**RE: SUBMISSION ON THE METROLINK ON BEHALF OF SAINFOIN PROPERTY COMPANY LIMITED REGARDING LANDS AT DARDISTOWN, CO. DUBLIN.**

**ABP Ref. NA29N.314724**

**Description - MetroLink Railway Order – Estuary through Swords, Dublin Airport, Ballymun, Glasnevin and City Centre to Charlemont, Co. Dublin**

**Figure 6: Proposed layout of Dardistown depot (Source: TII)**

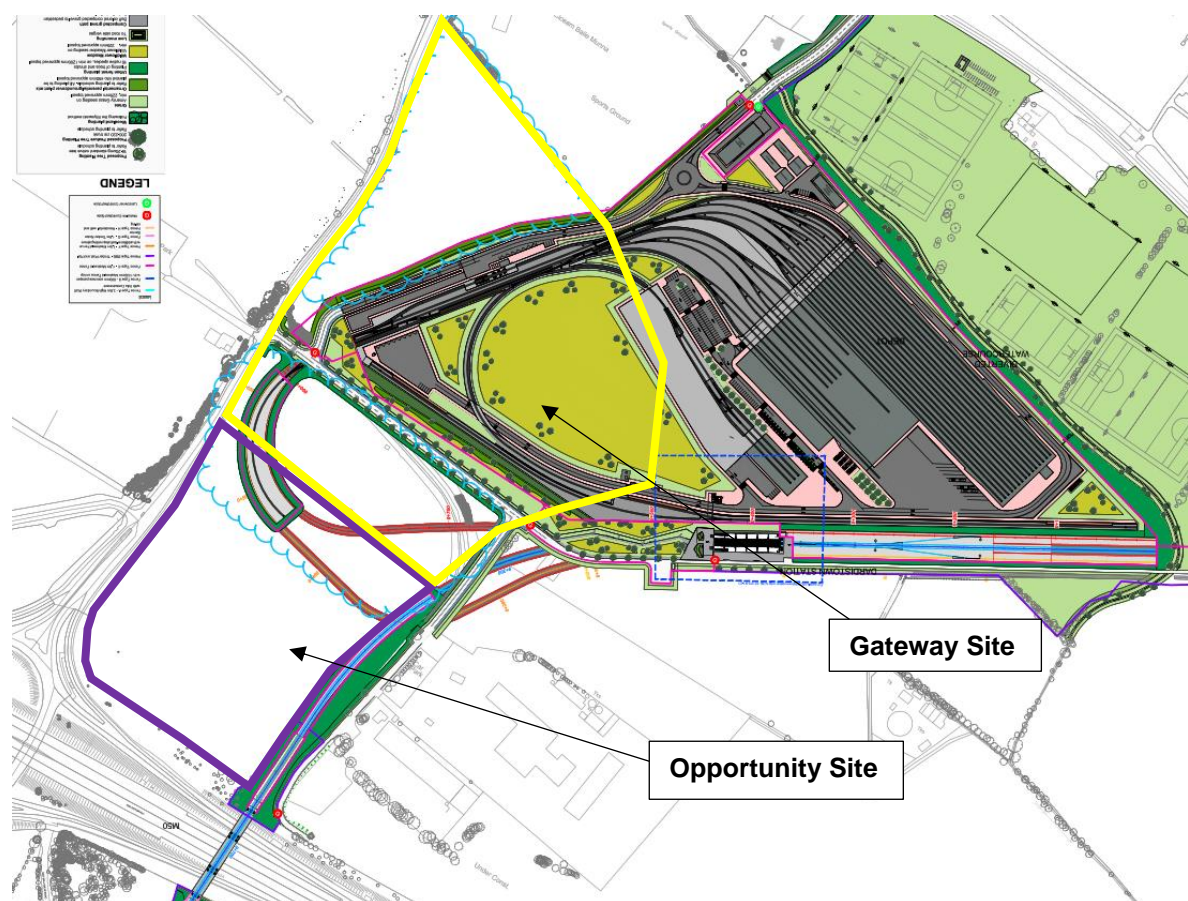
The current proposal as identified in Figure 3 below involves a very extensive land take from our client's property at Dardistown. It makes the potential development of the opportunity site to the southwest and the gateway site to the west significantly less viable. Indeed, the viability of the entire development of this prime land bank is severely compromised by the location of the proposed depot. It will create a high level of fragmentation of our client's landholding, significantly diminishing the development potential of these lands.

Figure 6 above identifies the impact the depot and connecting lines will have on the site. The gateway site to the west is now significantly reduced and fragmented as a result of the railway lines connecting the depot with Dardistown station. As these lines are not proposed to be covered, it will result in significant barriers to movement, adverse impacts on future development, adverse noise impacts at operational stage resulting in significantly reduced potential for creating a coherent urban form and placemaking appropriate to an urban context and integration between blocks on the gateway site. The fragmentation has also resulted in significantly reduced plot sizes which will reduce their developable potential. This area of the LAP lands is intended to provide a gateway into the entire area, however, as a result of the MetroLink depot at this location, the site’s developability is significantly less viable and is less likely to act as a gateway to the entire lands, as provided for in the statutory Local Area Plan for Dardistown.

**Figure 7: Potential Land Take (Source: TII)**

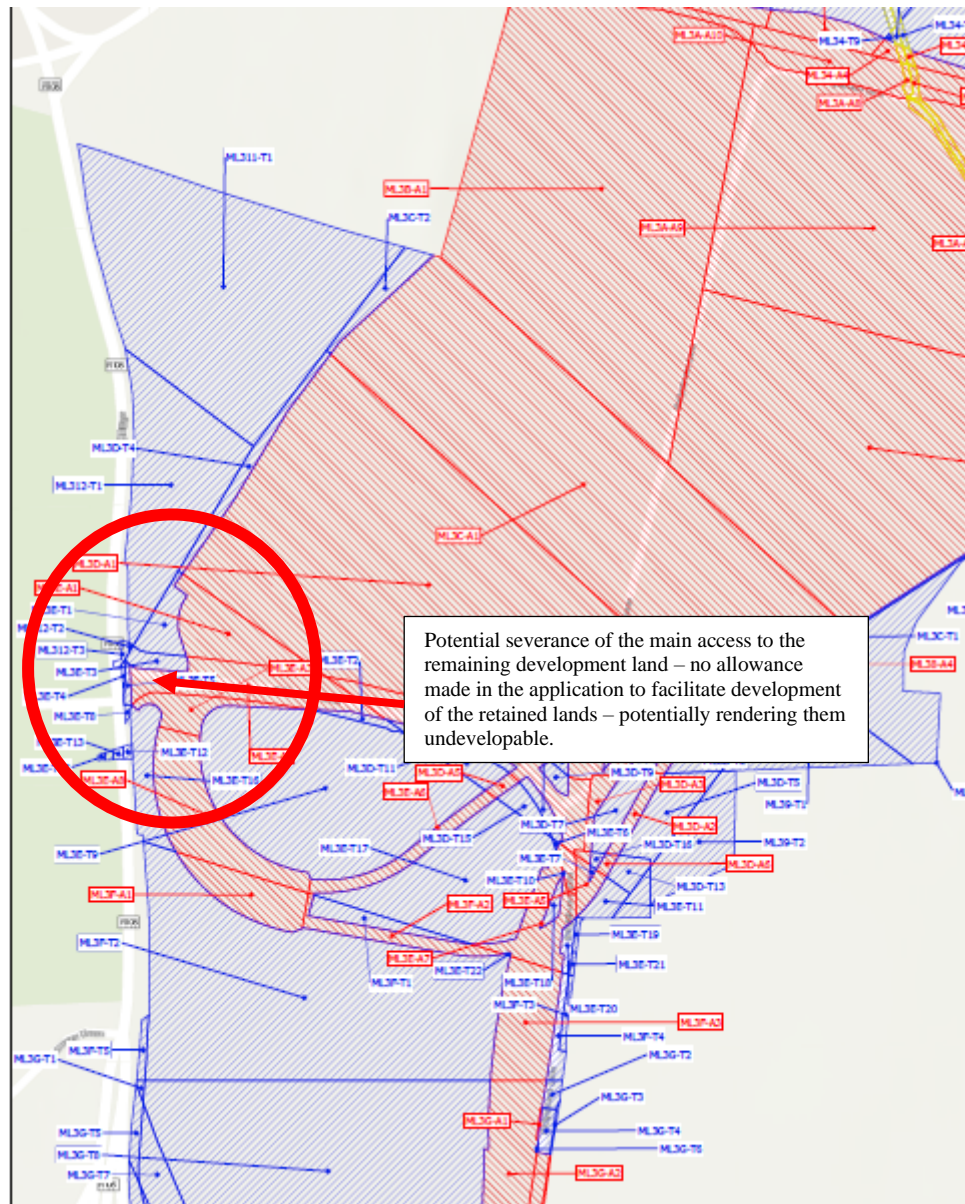
The proposal allows for permanent and temporary acquisition of lands at the interface of the lands with the Naul Road. This is the current access point for the lands and the location has been identified as the most appropriate for an appropriate access to facilitate the proposed large-scale development.

The proposal is silent on this hugely important issue. There is no design or co-ordination allowed for between the route selection and access to the remaining lands.

The proposal cannot proceed unless an appropriate access road is facilitated as part of the development.

1. A proposal on a development access is designed and built as part of the scheme so as not to landlock this important development opportunity
2. That there is a change to the temporary land take acquisition as per Figure 7 above i.e. that lesser lands are included in the temporary land take and that the lands zoned "opportunity" are removed.

**Figure 9: Alternative Location within the Dardistown LAP lands (Source: Tobin Consulting Engineers)**

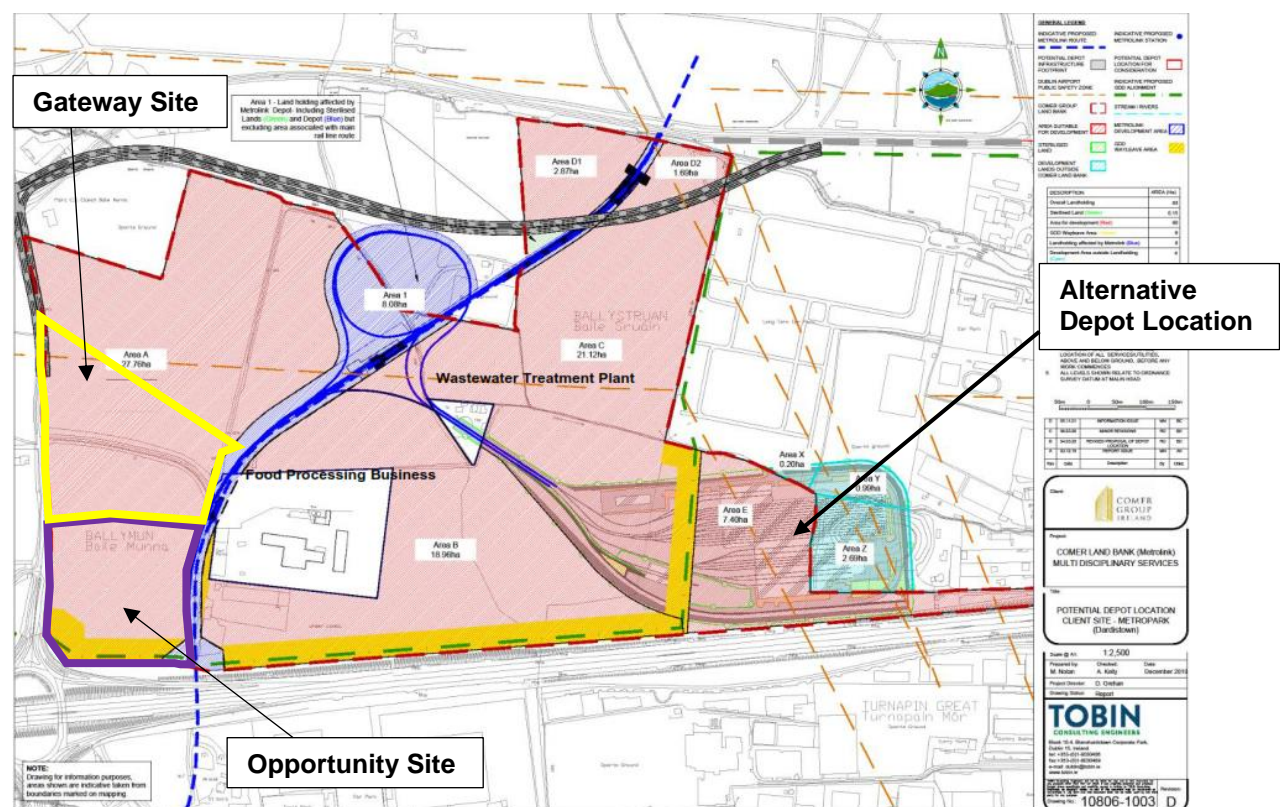
This site is considered more appropriate for the depot as it will have a reduced impact on the economic viability of the site as a whole and will result in less fragmentation of the site. The gateway and opportunity sites can be developed to their full potential which will have positive impacts for the rest of the lands. These lands are currently occupied by a go-kart track and a car dealership.

Whilst it is noted in the Railway Order documentation that the alternative option put forward by our client shown on the drawing was not of the scale now required for the depot, the option would easily be extended to ensure it is of the scale now required.

**Figure 10: Tracks connecting Dardistown station with the depot (Source: TII)**

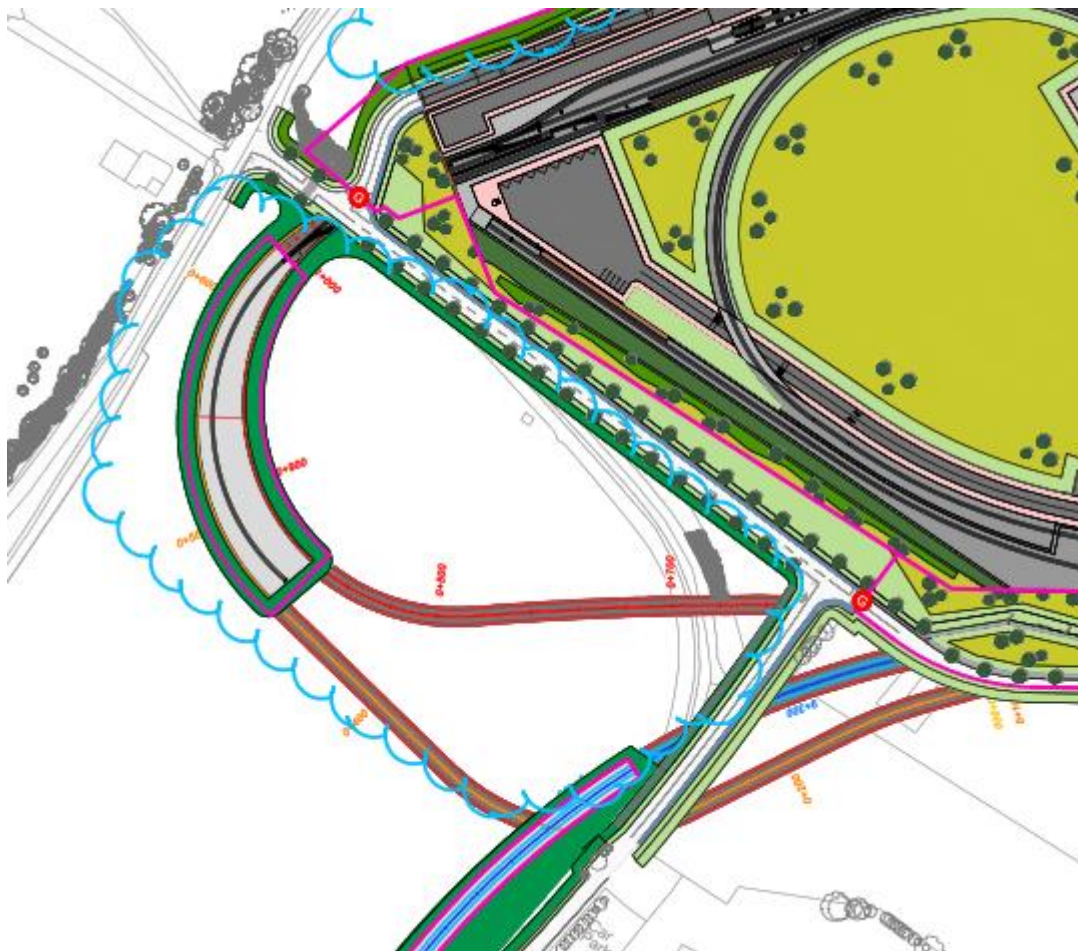
3. It is requested that the portion of the tracks which connects the depot to Dardistown station are cut and covered sufficiently to allow for landscaping to take place above. This will allow development between the lines to feel more connected and ensure the economic viability of the gateway and opportunity sites. Alternatively, it is requested that the track layout is amended in order to reduce the level of fragmentation to the gateway site. The current proposal breaks the gateway site into significantly smaller land holdings which will have a significant adverse impact on their developability. This will lead to a disconnect between the various buildings in this location and will have a negative impact on the functionality of a gateway site.

*Figure 21 - Single track pinch point on the route in/out of the proposed Dardistown Depot*

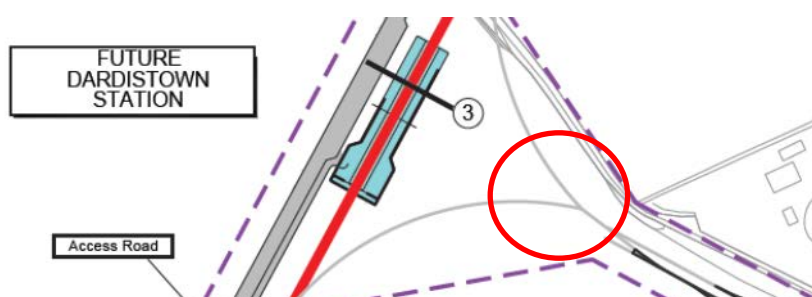
Operationally, additional Empty Car Stock (ECS) movements may be required by placing the depot at Dardistown (as opposed to either end of the line) to get rolling stock in place for commencement of services, depending on the planned service pattern. A loop or crossover at each end will almost certainly be required (regardless of depot location, see Image 4) to achieve the desired service frequency. This is likely to result in a net higher land acquisition than would be required if the depot was located at the north end of the route. The route layout into the Dardistown also appears to narrow to a single track at one point which further constrains movements in and out of the depot (see Image 5). This also presents significant performance risk as there is no operational contingency measure/alternative should there be any issues with the infrastructure at this pinch point.

Image 5: Single track pinch point on the route in/out of the proposed Dardistown Depot

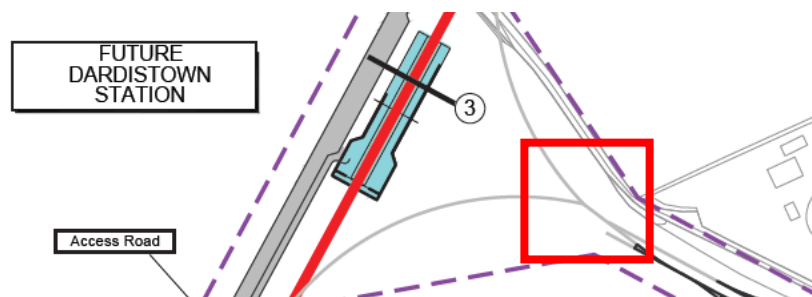
Operationally, additional Empty Car Stock (ECS) movements will be required by placing the depot at Dardistown to get rolling stock in place for commencement of services. A loop or crossover at each end will almost certainly be required (regardless of depot location) to achieve the desired service frequency – this is likely to result in a net higher land acquisition than would be required if the depot was located at the north end of the route. The route layout into the Dardistown also appears to narrow to a single track at one point which further constrains movements in and out of the depot. This also presents a significant performance risk as there is no operational contingency measure/alternative should there be any issues with the infrastructure at this pinch point.
